From: Rowell Umale <rumale@ifp.com.au>
Sent: Friday, 19 June 2026 10:47 AM
To: Monica Luo <MonicaLuo@logan.qld.gov.au>
Cc: WaterDA <WaterDA@logan.qld.gov.au>
Subject: RE: B4942 - 673 Silverwood Drive, Flagstone - Lot 1 RP45241 - Residential Subdivision (1 Into 526) - Water & Sewer Network Planning Request

Please see below for the water and sewer network analysis advice for 673 Silverwood Drive, Flagstone:

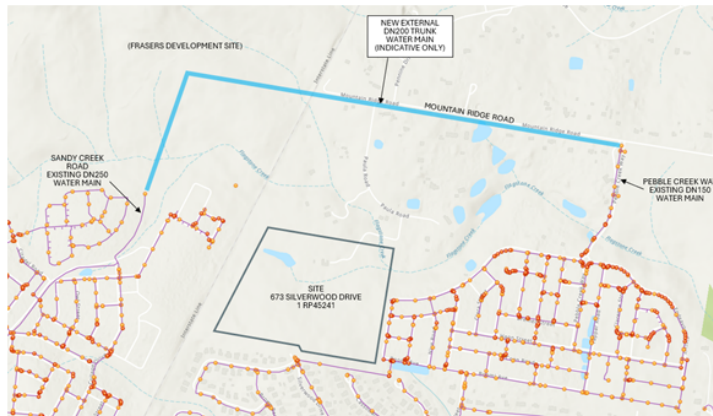
- There is competition for the existing capacity available through the existing interim supply (DMA097) with Frasers New Beith who are also responsible for providing the ultimate connection and DMA191 feed. However, with the imminent commissioning of the Chambers Flat SRWP Connection Q4 2026 modelling has confirmed that the network can support the 526 lots in this application in addition to the initial Frasers New Beith loads and existing approved development in Pebble Creek
Does the 'Ultimate connection and DMA191 feed' refer to a new DN200 water main along Round Road connecting water mains in Sandy Creek Road to Pebble Creek Way (snippet below)?

Is my understanding correct, commissioning of the Chambers Flat SWRP Connection is a separate network strategy that is going to provide some interim capacity to the area?

Essentially yes, A DN200 on Mountain Ridge Road will initially supply Fraser early stages until the Ultimate connection /extension of Sandy Creek Road (in DN300) which then ultimately connects at Round Mountain Reservoir. When Sandy Creek Road is connected and a DMA feed delivered the supply along Mountain Ridge Road will reverse and DMA191 will be formed and segregated from DMA097

Yes, due to be commissioned later this year.

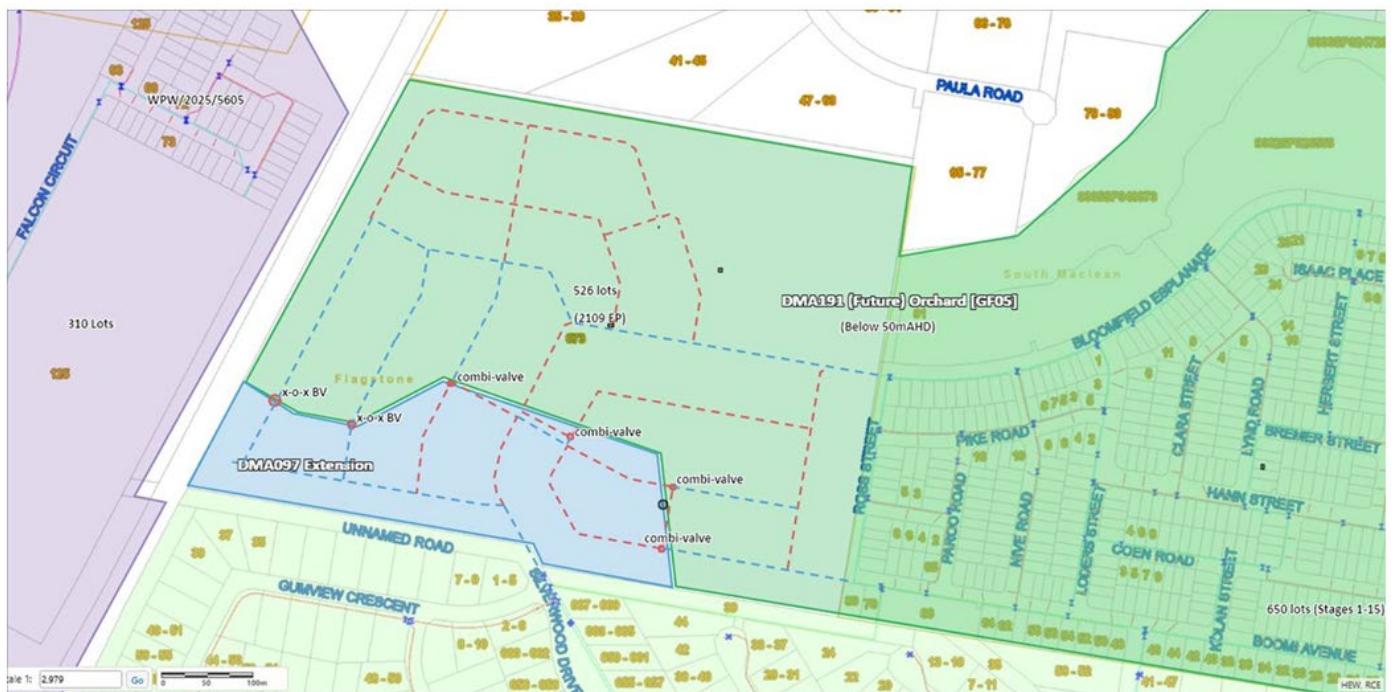
- Recommended DN100 (red)/DN150 retic (blue) is shown below along with 4 combi-valve tees and two standard boundary valve arrangements (x-o-x) to manage DMA boundaries, contingency and WQ risks

SPS162 services the proposed development. A plan of the system is shown below.

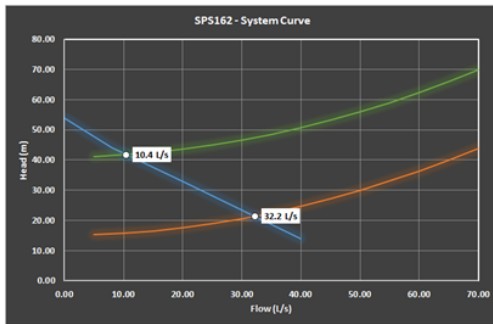
The pump rate is estimated at 32 L/s (SCADA – Flow Meter) when operating alone. This flow rate compares well with that derived from the system curve (below) for when it is not injecting, see below. However, when injecting into the rising main servicing Bradman Street Pump Station the capacity reduces to less than 10 L/s (when Bradman Street pumps are operating).

The existing pumps were interim and installed to meet the initial development and the capacity of the pump station has been exceeded.

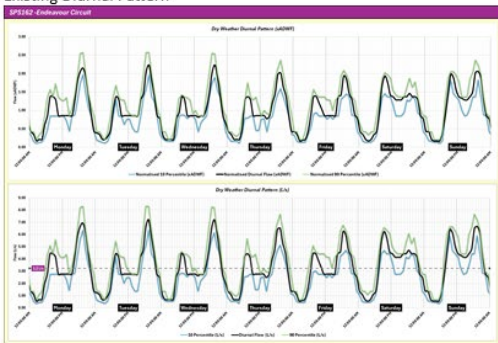
The proposed lot layout has the total number of lots to be serviced at 517 dwellings. This is an increase on the current growth model that allows for 430 dwellings. The **design load** from the proposed 517 lots is estimated at 25 L/s.

The estimated total load for the SPS161 catchment is as follows:

- Load excluding proposed development = 3,880 EP (design flow 45 L/s)
- Ultimate load including proposed development = 5,430 EP (design flow 63 L/s)

The design flow for the total catchment including the proposed development is estimated at 63 L/s. This requires the pumps to be upsized to meet ultimate loads for this development to proceed.

The **capacity of the existing DN225** from the development connection through to the pump station is likely to be operating close to full capacity but adequate.

1. The capacity of the existing DN225 trunk sewer servicing this development is adequate
2. The existing interim pumps will need to be replaced with ultimate sized pumps for the development to proceed

Recent performance

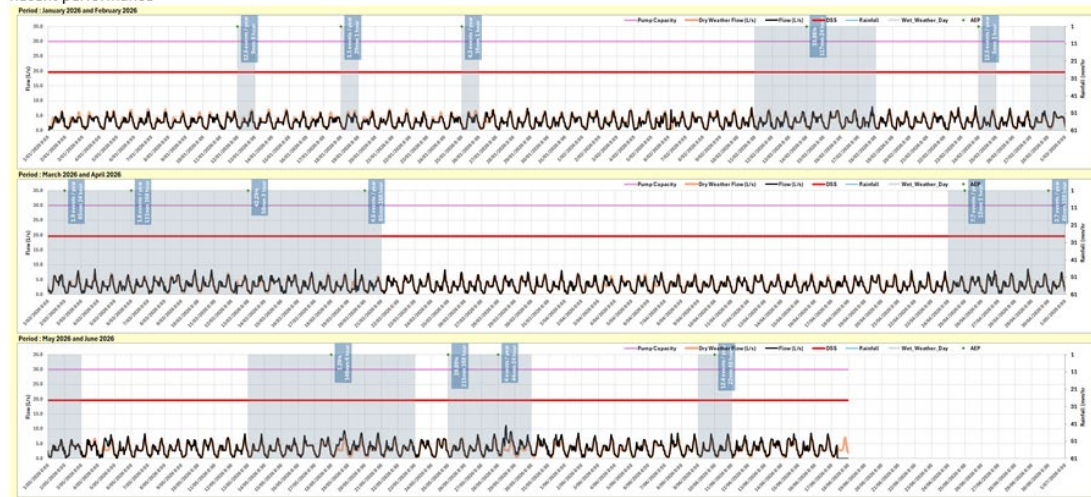
This can be seen in its recent performance during a relatively small event on the 12/03/2026 where the wet well approached 70% (100% is overflow level).

With regards the pump capacity of SPS162 – Endeavour Street. The pumps need to be upgraded as soon as possible.
